**Staff Report to the
Southeast Town Design Review Committee
June 9, 2016 & July 14, 2016**

**MPL2016-00020
ITEM #1
POST SETDRC**

PIONEERS HOLIDAY INN EXPRESS

REVISED SITE PLAN

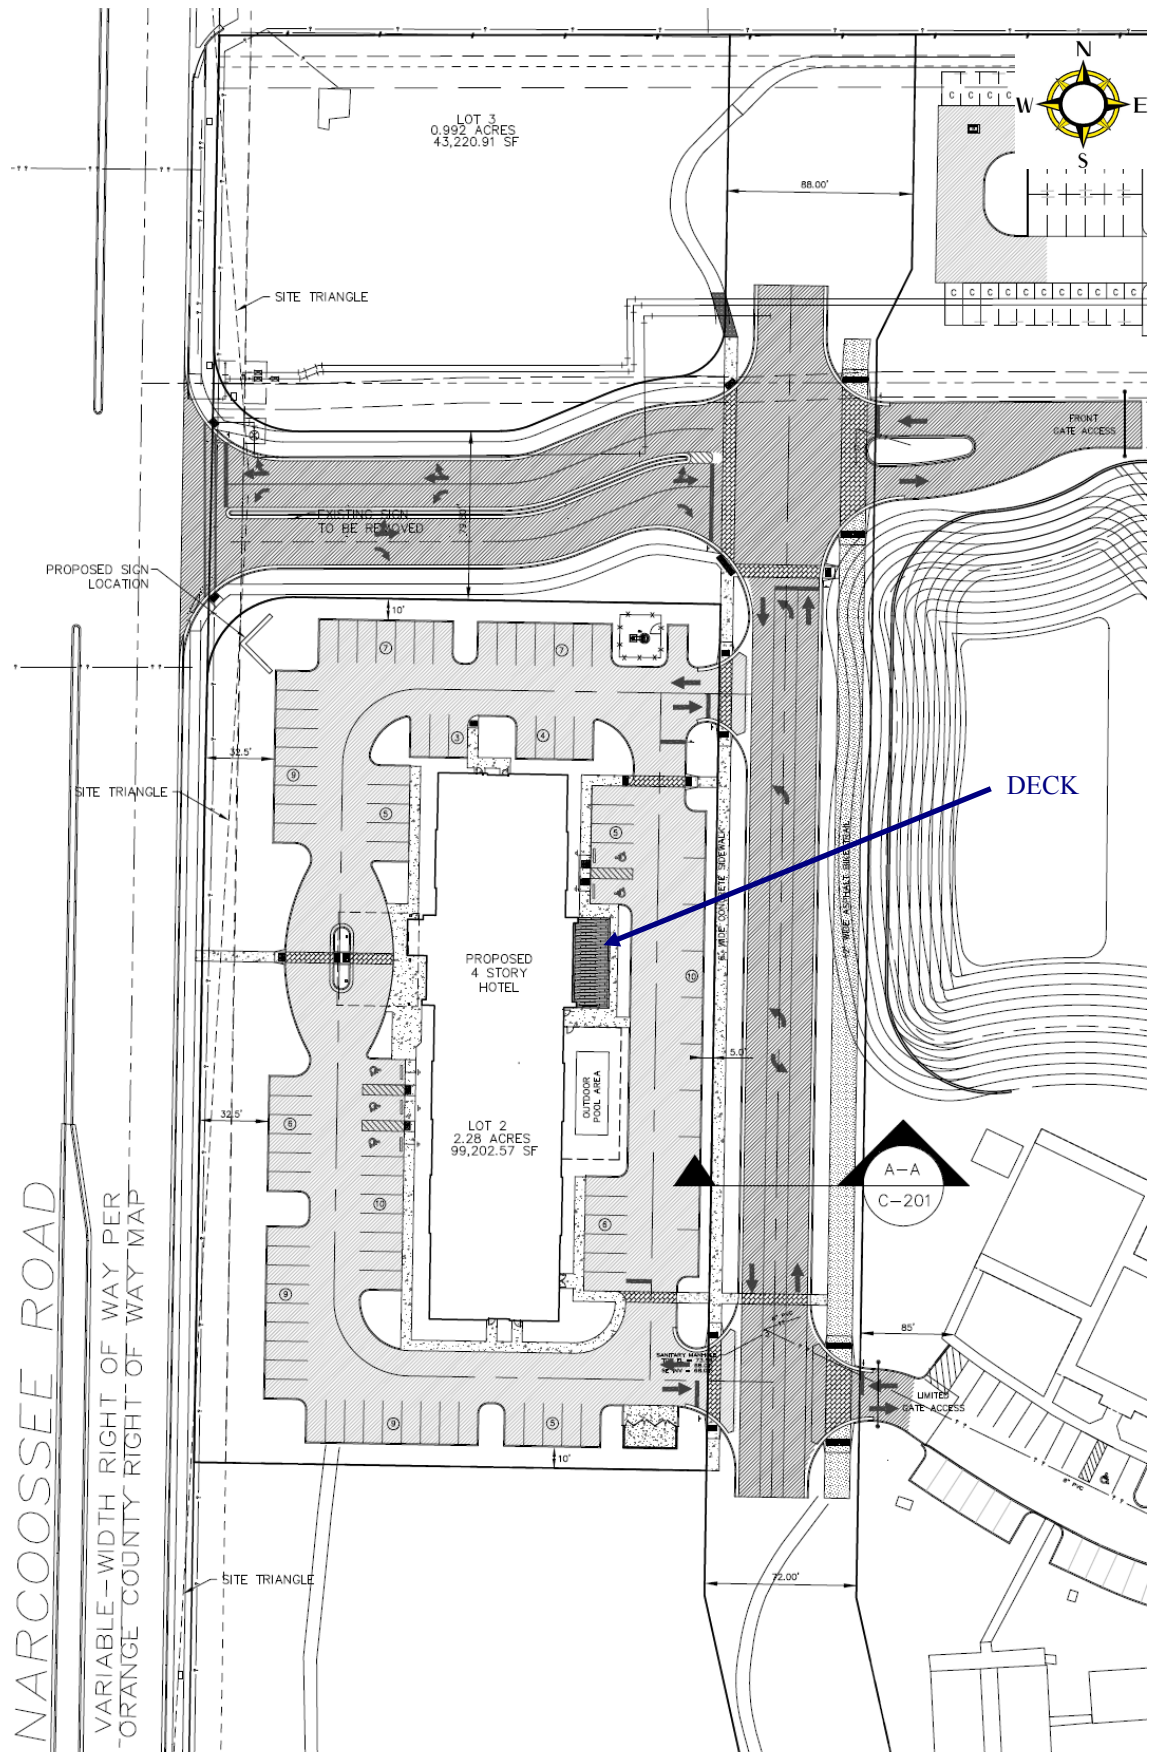
The Pioneers PD specifies a maximum ISR of 0.85 for properties designated as Village Center. The proposed ISR for this development is 0.623. The applicant has submitted a site plan (page 7) that shows stormwater managed by a pond directly east of the subject site.

The site plan shows a walkway along the north, east, and west sides of the building site perimeter. A publicly accessible walkway leads directly from Narcoossee Road to the establishment's front door, crossing a vehicular travelway in the process.

Primary automobile access is on the North-South road at two locations on the east side of the building (north and south). Automobiles enter from the North-South road and circle around to the west side of the building where the main entrance is.

There is an existing sign located within the median of William Carey Drive. City code requires for this sign to be removed in order to preserve site lines for pedestrians and automobile drivers. The site plan shows a new sign location at the northwest corner of the subject property. This sign is intended to serve as signage for the Holiday Inn Express and the Pioneers campus. A complete signage package will be required for appearance review at the time of final site plan permitting.

PROPOSED LANDSCAPE PLAN (SOUTH PORTION)

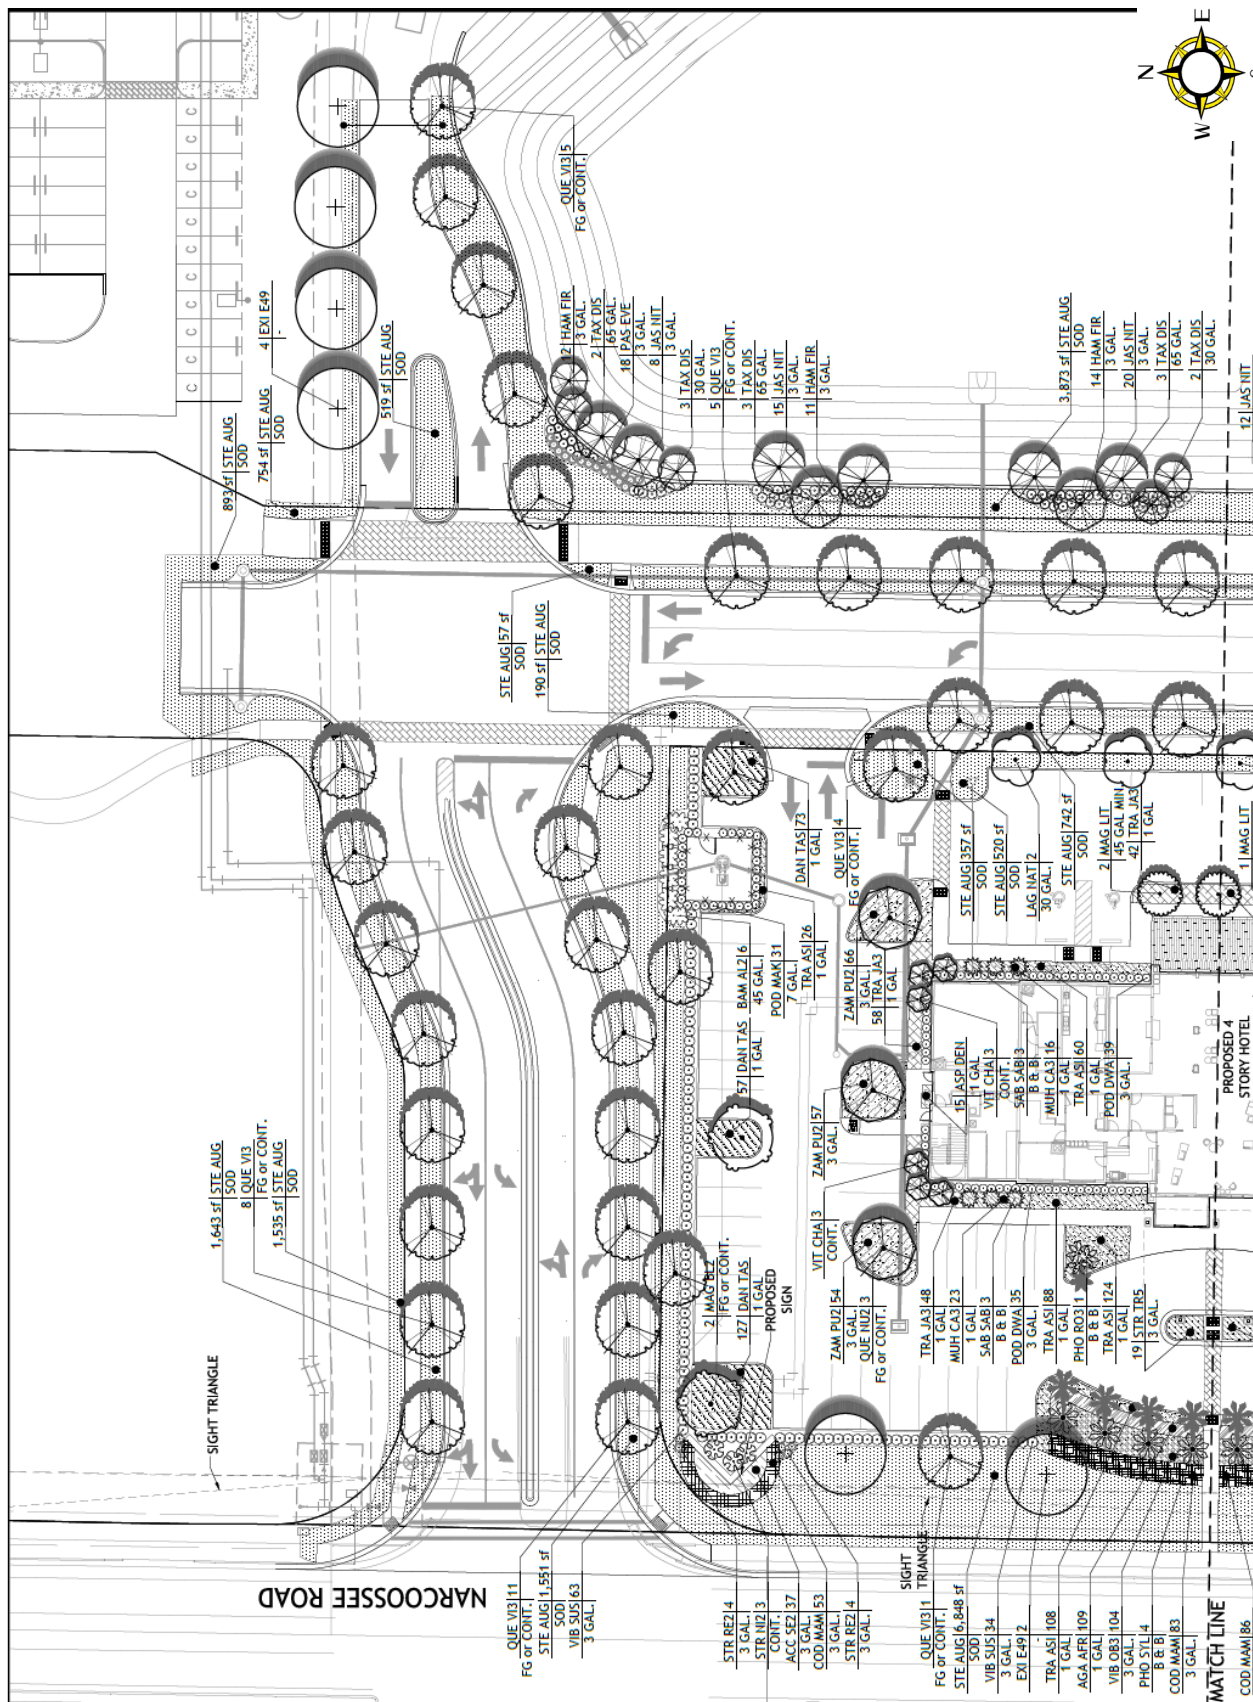
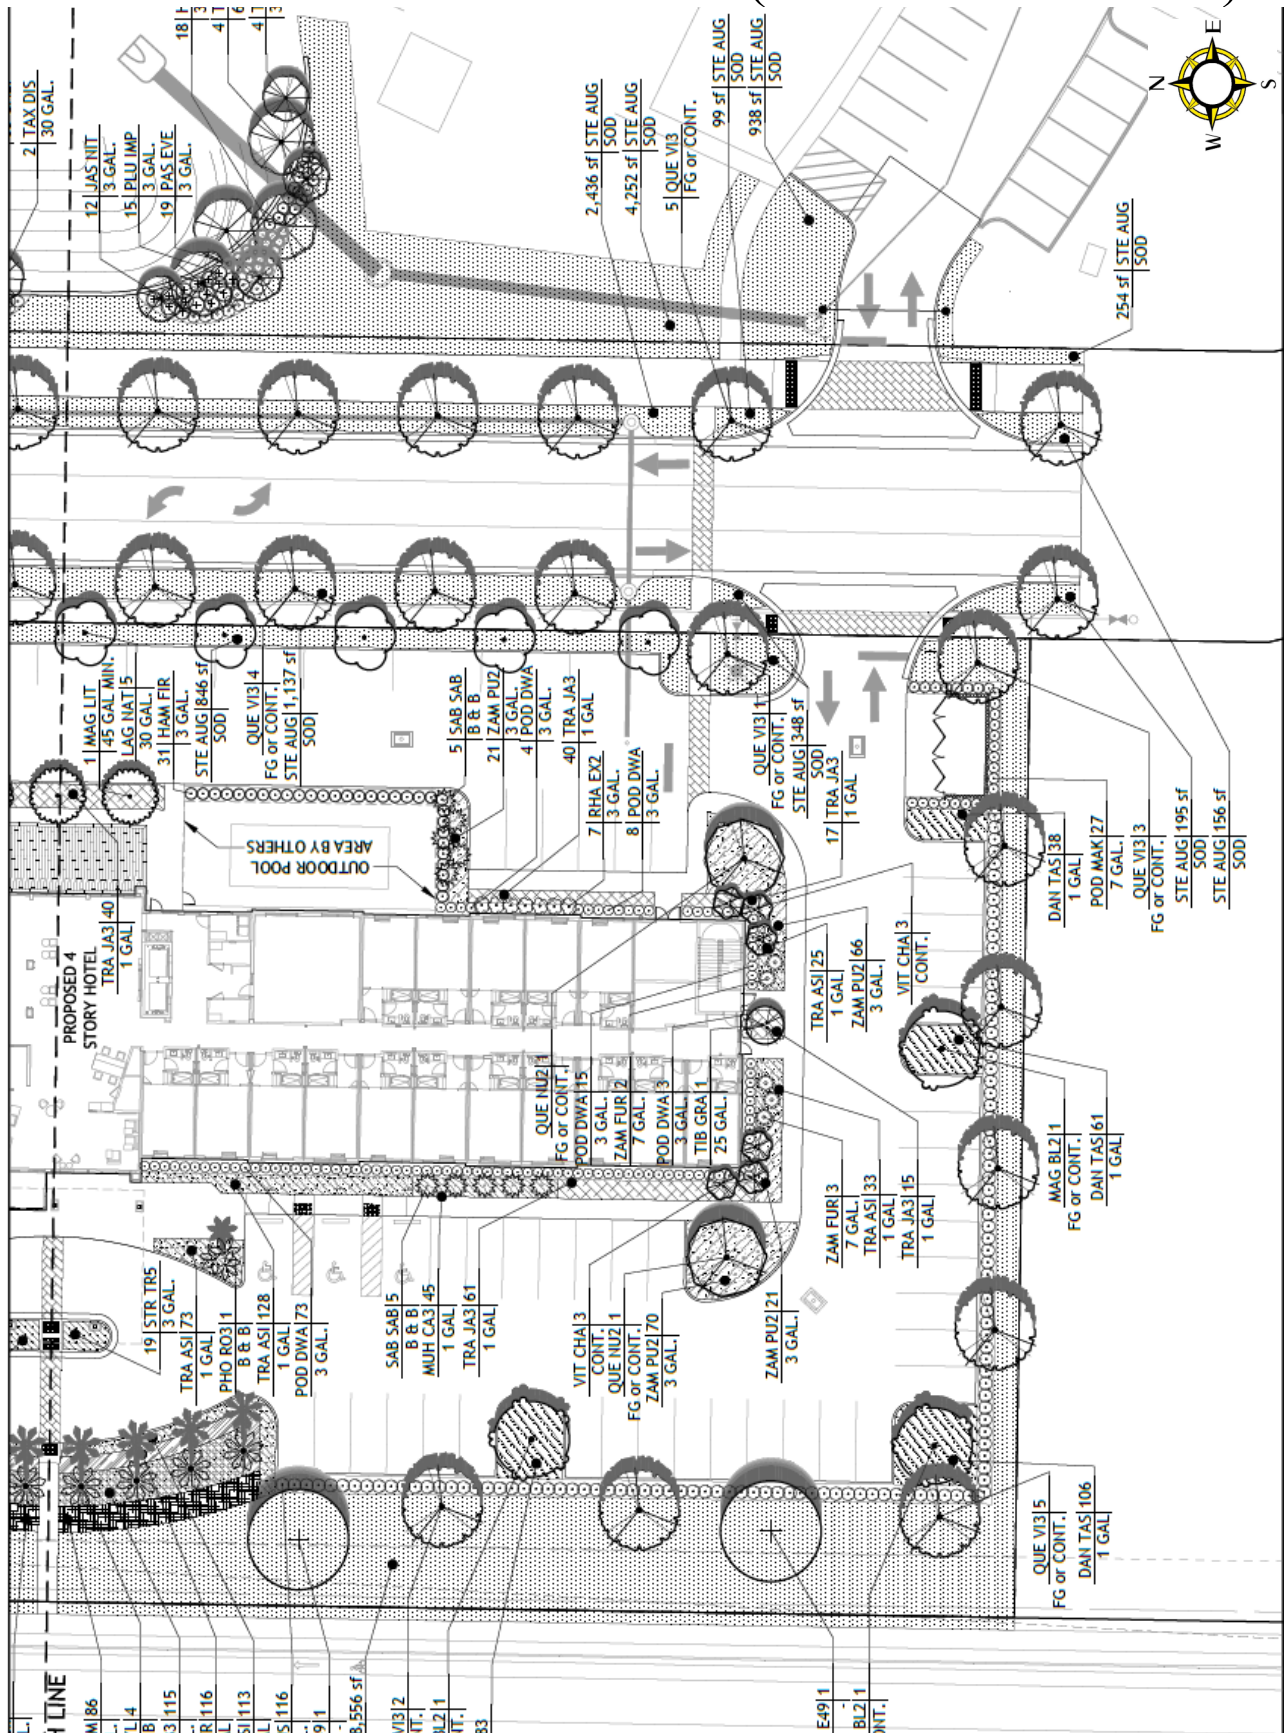
The applicant has submitted a landscaping plan (page 8) with this application, including a plant list (page 9) which meets conventional LDC standards. Section 68.324 emphasizes that broadleaf trees should predominate in parking areas.

CROSS SECTION OF NORTH-SOUTH ROAD

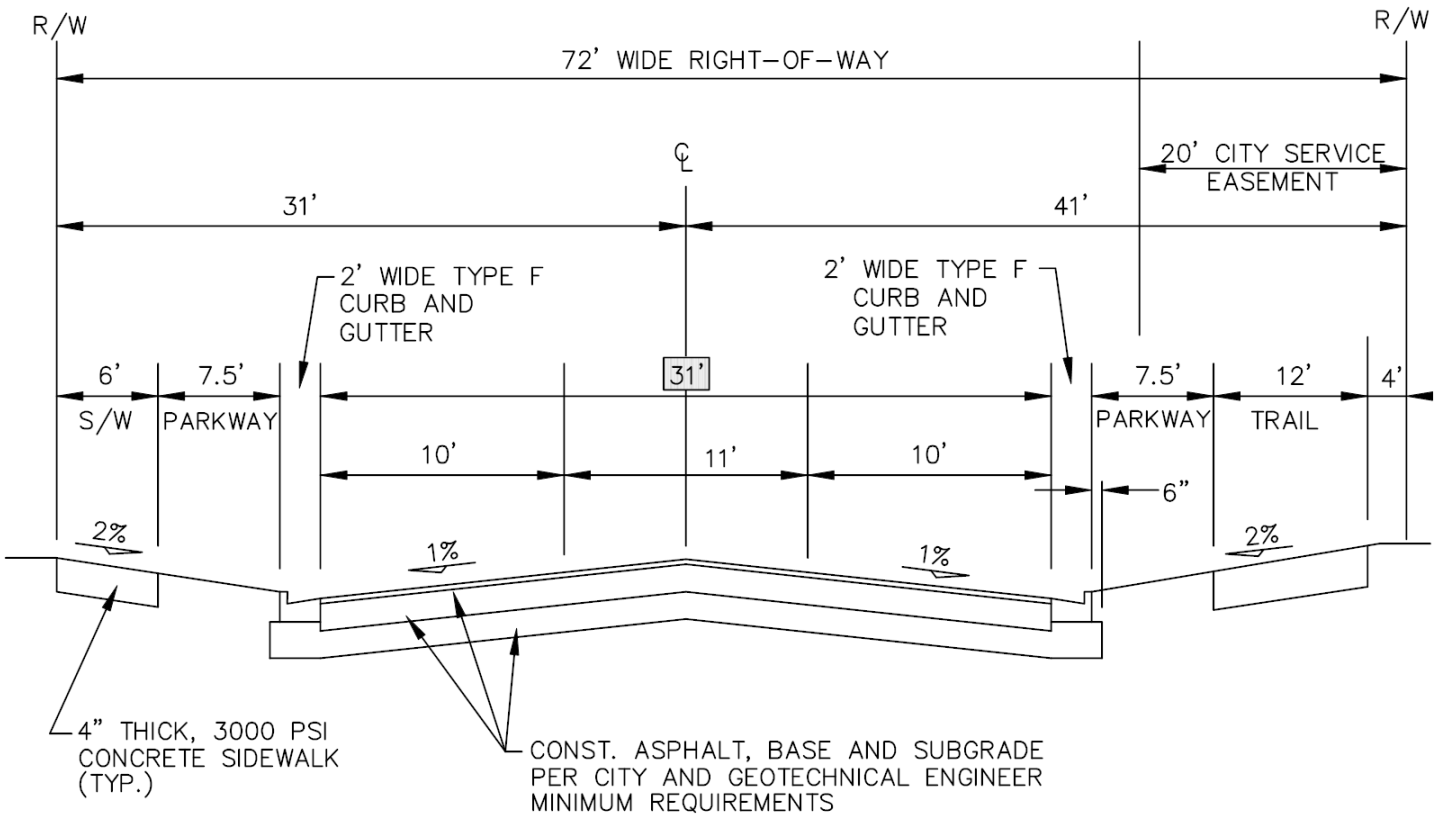
Typical two-way arterial roads in Village Center include parking, bicycle lanes, sidewalks, and at least 67 feet of right-of-way. Because there is already ample existing parking, street parking spots on the North-South road are not required. Plans show a 12 foot wide multi-use trail along the east side of the North-South road and a 6 foot wide sidewalk on the west. The total right-of-way equals 72 feet (see page 10 for North-South road cross section).

PROPOSED ELEVATIONS (APPROVED AT JULY 14, 2016 SETDRC)

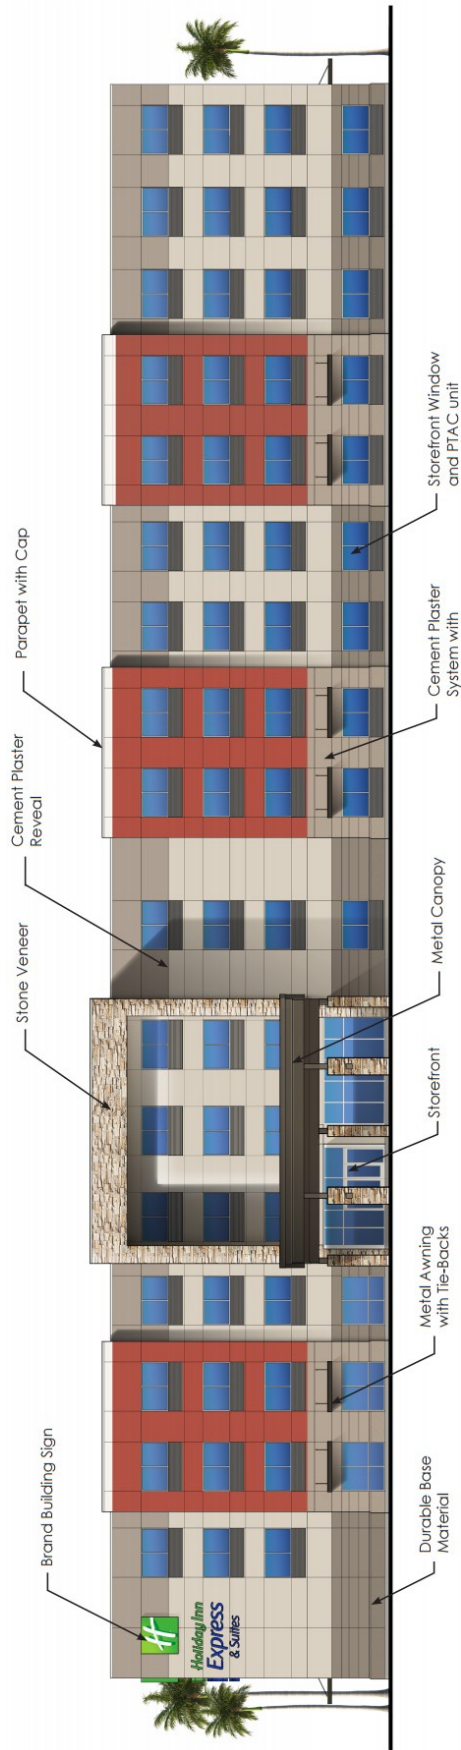
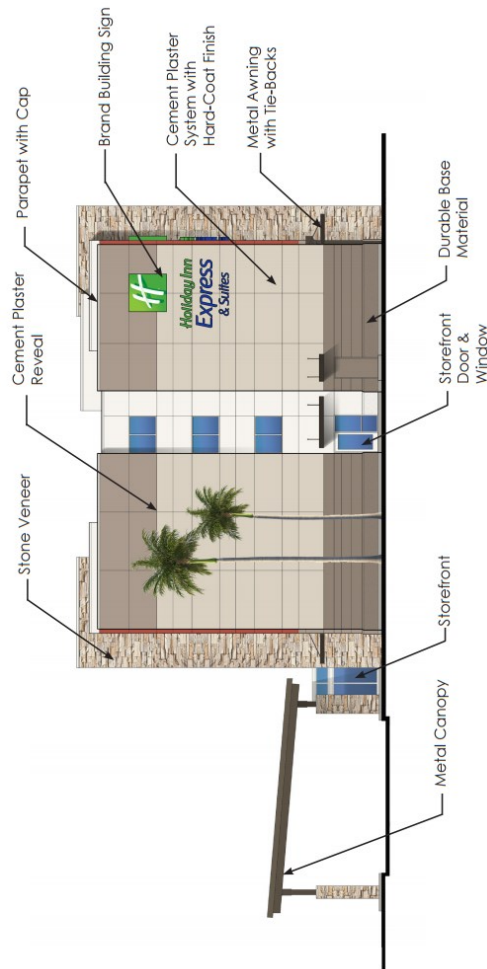
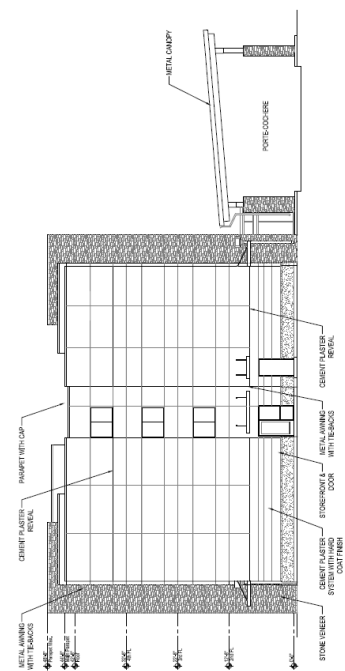
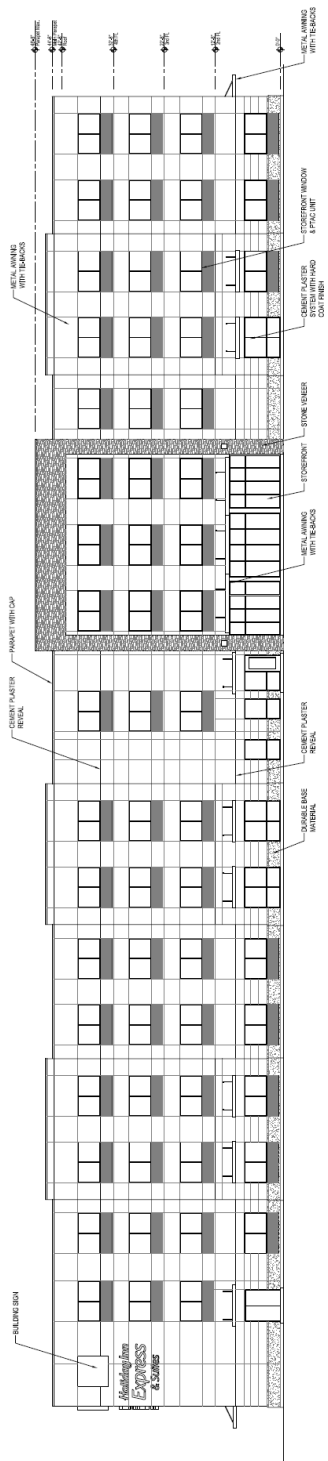
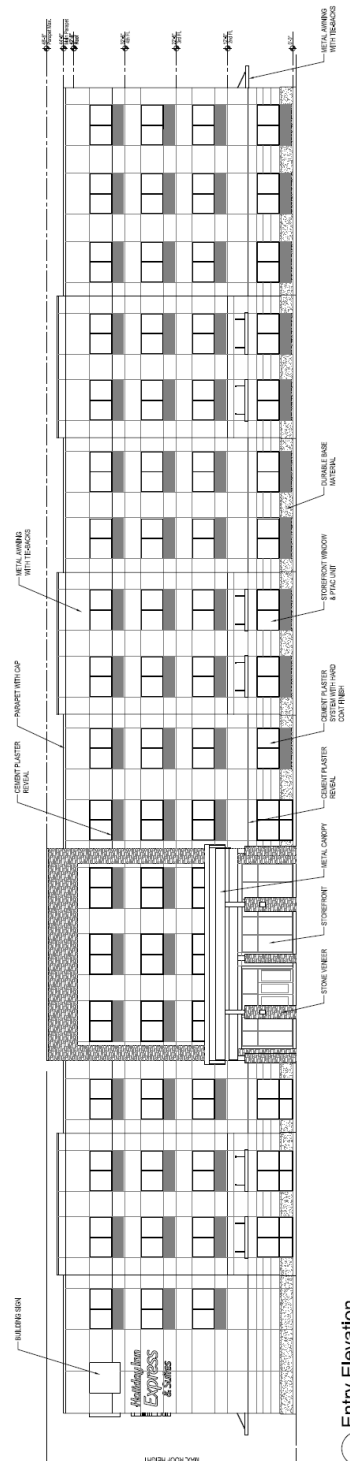
In the Southeast Sector Plan, height is limited by the number of stories, not the overall height to provide variety to the skyline in the mixed use centers. Commercial buildings shall have no more than 25 foot floor to floor heights. According to the Pioneers PD, Parcel A allows for a height limit of four (4) stories. The proposed elevations on pages 11 and 12 show a maximum height of four (4) stories totaling 60 feet.

- Provide a durable base at water table with a stone cap. Material may be brick or stone. This is to occur at all locations where EIFS is in contact with the ground.

- Provide architectural grills at all window PTAC locations or spec a material that matches the material use in its area. Adding mullions at all window locations is encouraged but not required. The mullion design should match the architectural design of the building.
